**MINUTES
BOARD OF ZONING APPEALS
REVIEW MEETING
LAKEWOOD CITY HALL
AUDITORIUM
FEBRUARY 15, 2024
6:30 P.M.
MEETING IS RECORDED
<https://www.lakewoodoh.gov/videos-2/>**

**4. Docket No. 12-19-23
12500 Edgewater Dr.
The Waterford Condominiums**

5. **Docket No. 02-05-24**
1352 Kenilworth Ave.

6. Docket No. 02-06-24 1062 Leedale Ave.

12500 Edgewater

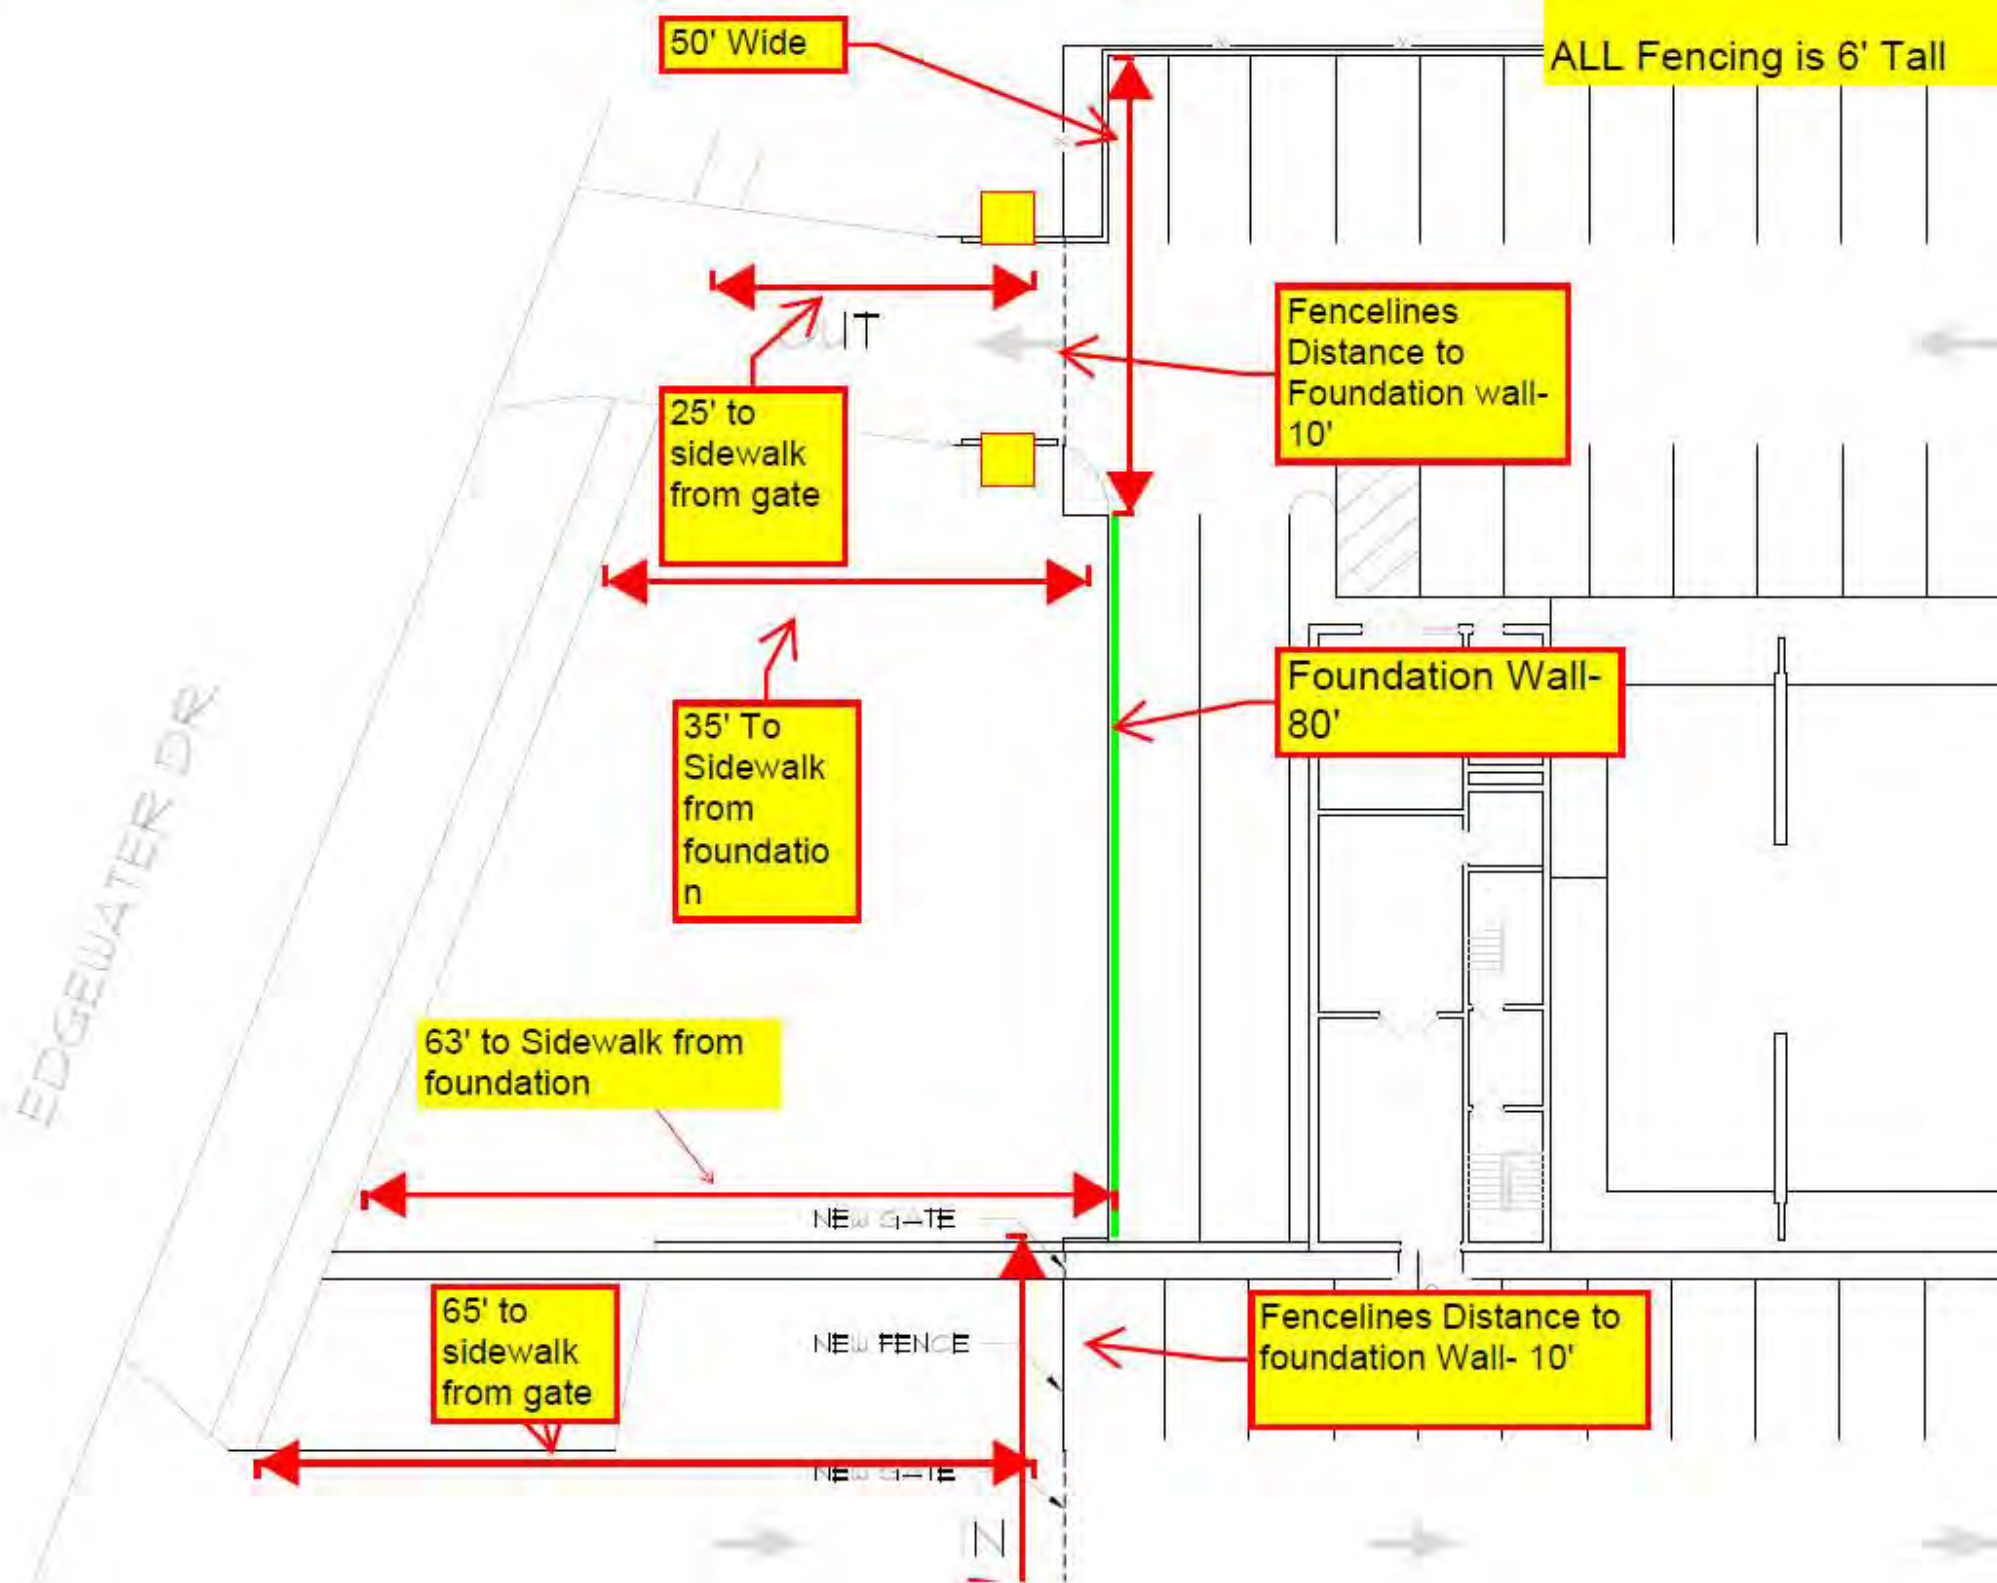
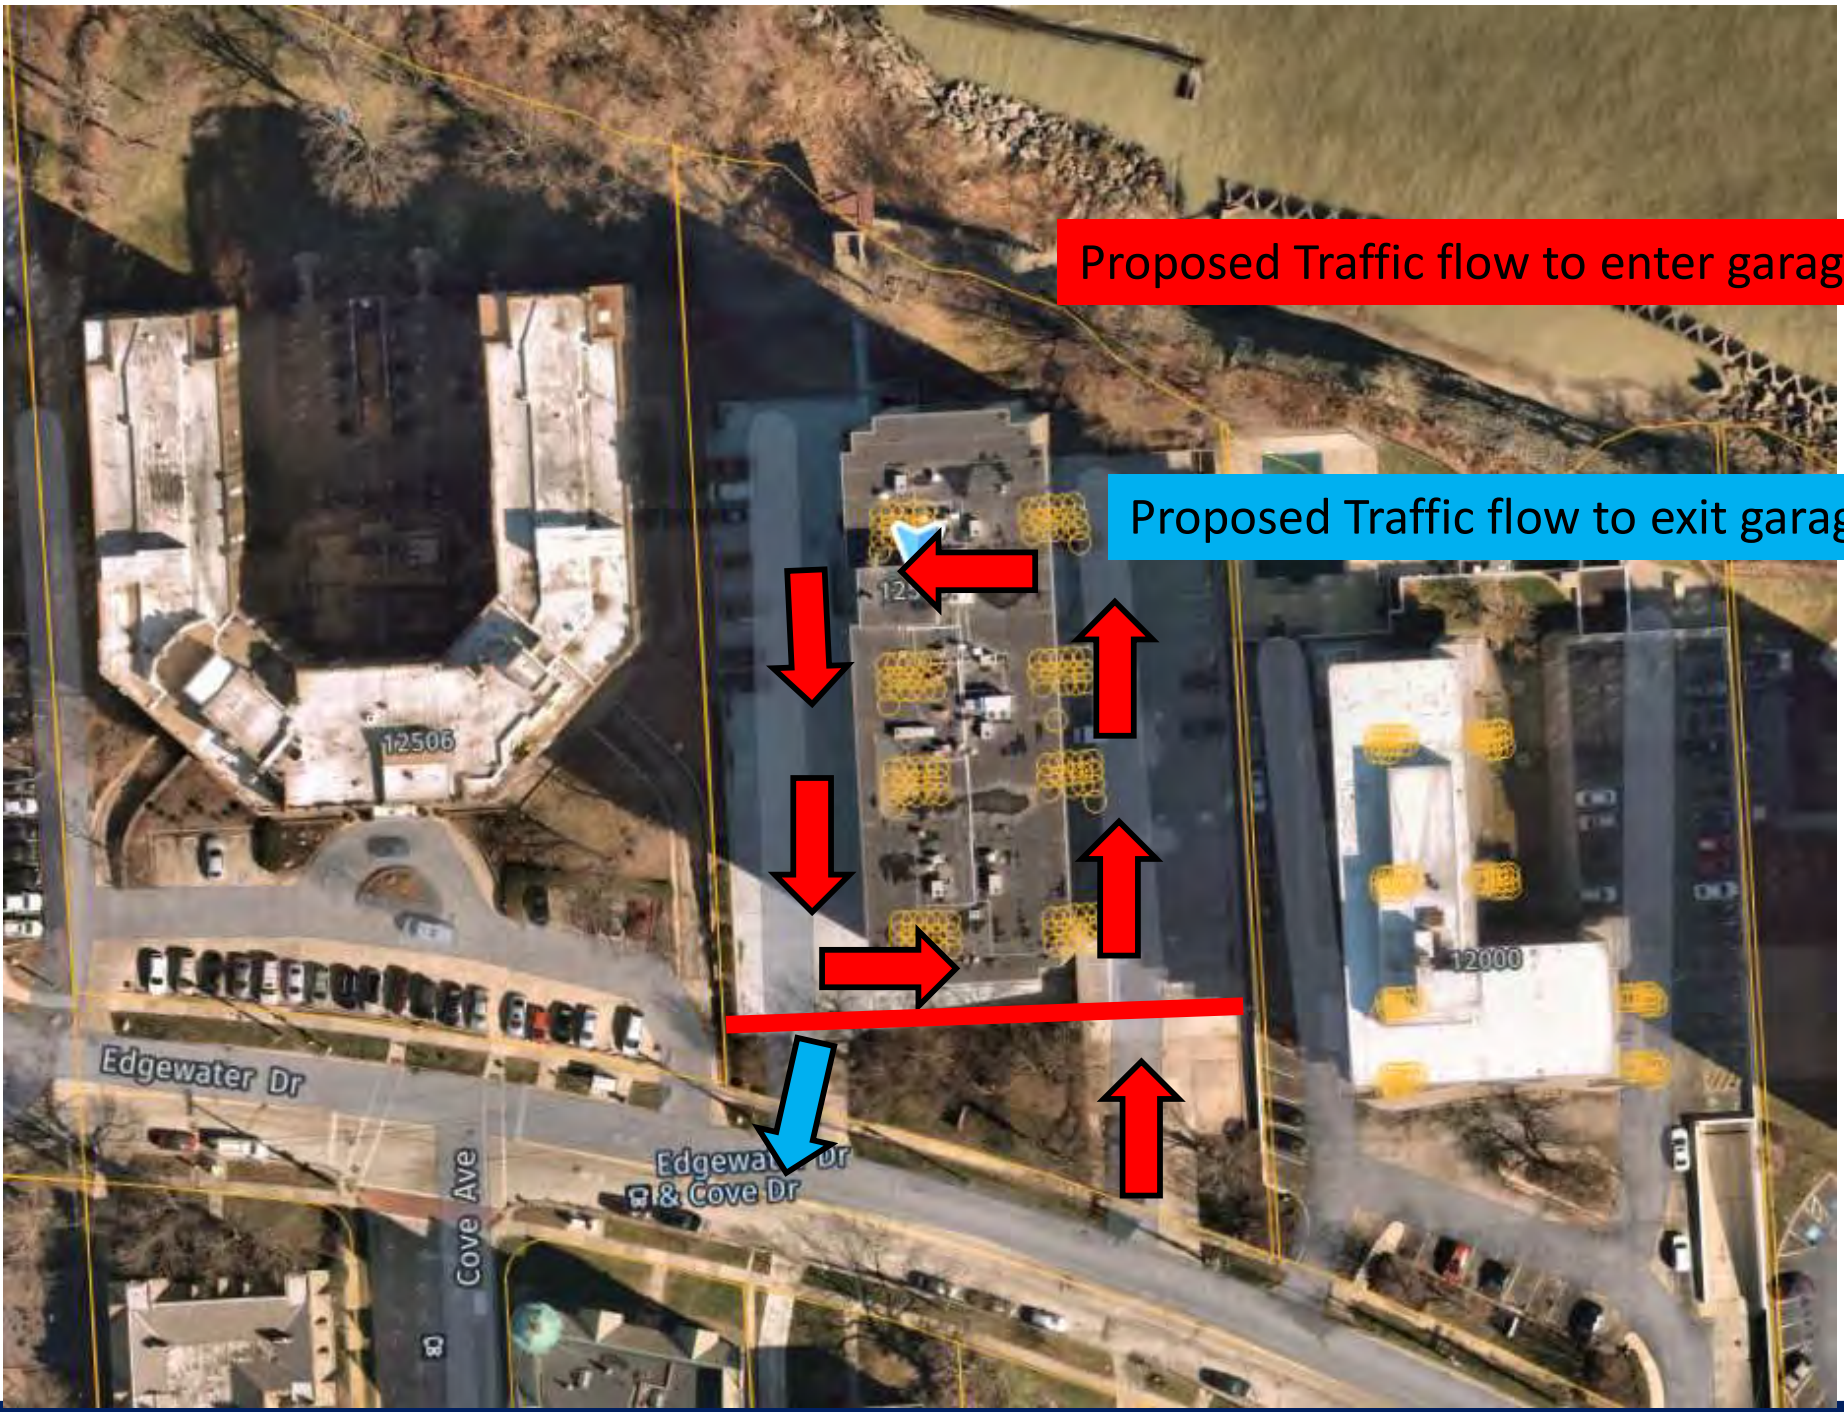
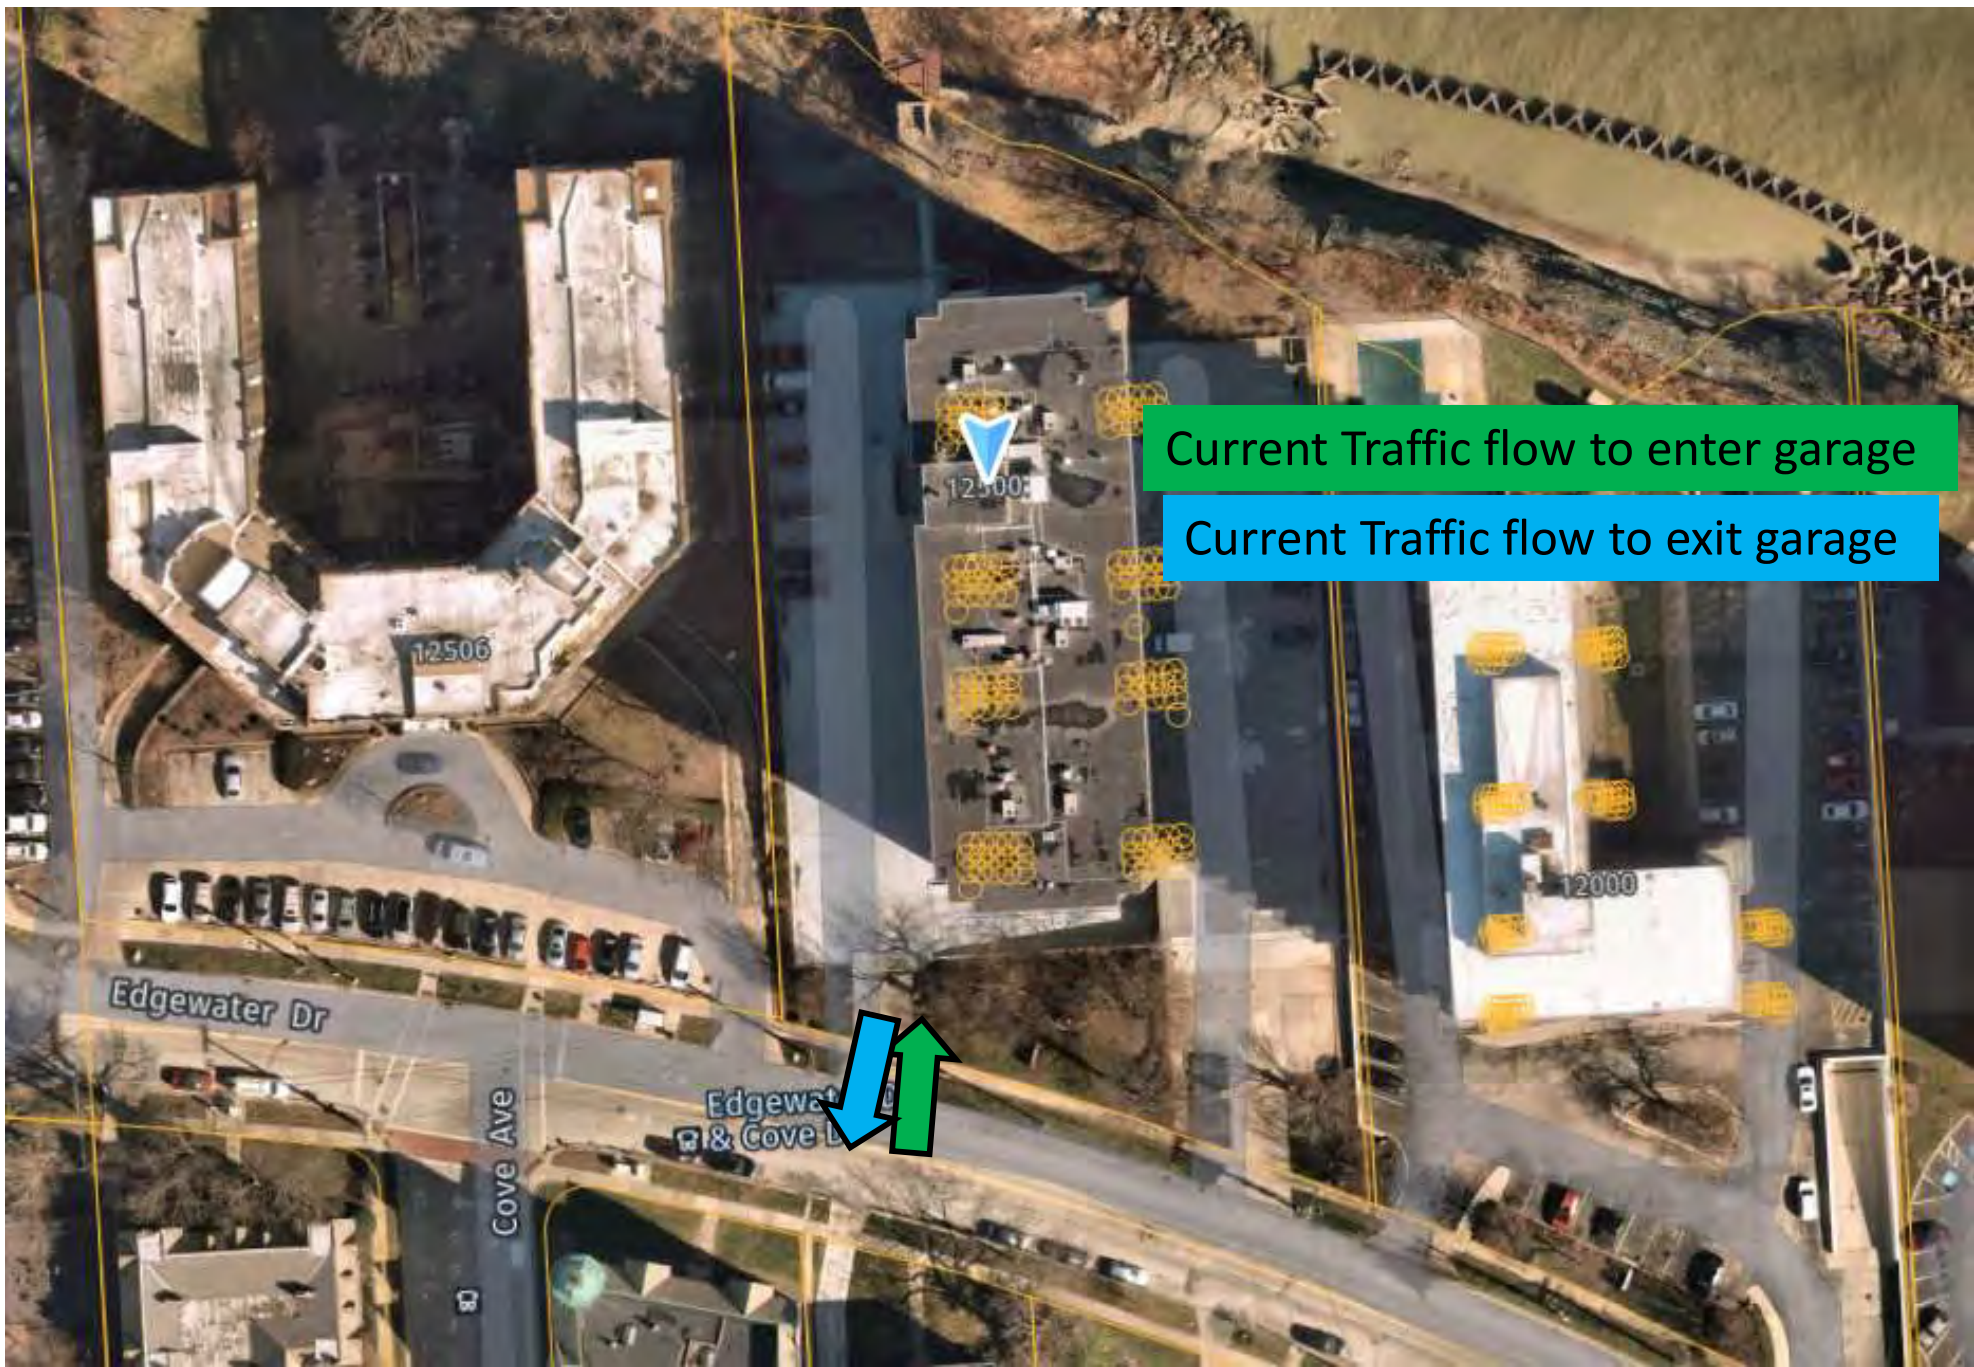
- An additional reason for the fence given by the condominium association is to prevent heavy trucks from driving onto the garage deck, which applicants has stated can damage the integrity of the underground garage.

- A stop bar and a height limiter could be installed without a variance to prevent large trucks from driving onto the parking deck
- If the fence were placed at or behind the front foundation line no variance would be required.

- There are no other such fences with gates at the other properties on the north side of Edgewater between W 115th and Cove
- The Public Works director does not oppose the installation so long as there is no adverse impact to traffic flow on Edgewater Drive due to the gates. If traffic flow on the public street is impacted because the gates are causing traffic to back up onto the public street the project will need to be reevaluated.

- The Applicant has worked with the fire marshal to ensure that the proposal will meet safety standards
- There is one ramp down into the garage on the west side of the building. The garage has roll-up doors for security which are keep closed.

- Currently traffic to the garage is in and out is mainly through the west entrance. The proposed set-up would only allow cars to enter on the east side, and loop around the property to enter the garage and exit only on the west side

A motion was made by Mr. Santiago, seconded by Ms. Bolino to **APPROVE the request for eight variances as proposed.** Mr. Alexander, Ms. Bolino, Mr. Markling, Mr. Pigott, and Mr. Santiago voted yea; the motion passed.
